## BRL SIS (Sales Information Service)

### Product Bulletin – Aluminum Structural Framing

## New 90x360H Profile

PB-MGE07-06 US

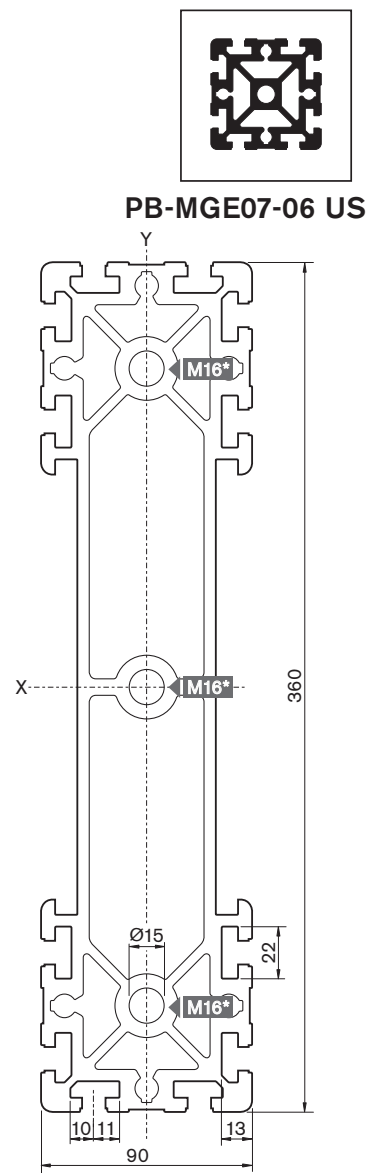
Rexroth 90x360H profile has always consisted of two halves that were clamped together with two extruded aluminum strips. The 90x360H Profile has been redesigned and is now available as a solid extruded aluminum profile. This change takes effect immediately. Because of the extent of the change, new part numbers have also been assigned for some of the machining options. The balance of the machining options retain the old part numbers. Pricing for 90x360H profile has not changed.

In addition, the single stick number, 3842500215, has been eliminated. Effective immediately all 90x360H Profile will be sold only in cut lengths. The maximum cut length is changed from 5000mm to 6000mm. The following list reflects the complete 90x360H Profile product offering. Please update page 2-50 of your Aluminum Structural Framing System Catalog Version 4.0 with these new part numbers.

Technical Data		Old	New
Moment of inertia	$I_x$ [cm <sup>4</sup> ]	14520	14065
	$I_y$ [cm <sup>4</sup> ]	683	710
Section Modulus	$W_x$ [cm <sup>3</sup> ]	807	781
	$W_y$ [cm <sup>3</sup> ]	152	157
Weight	m[kg/m]	26.70	24.4
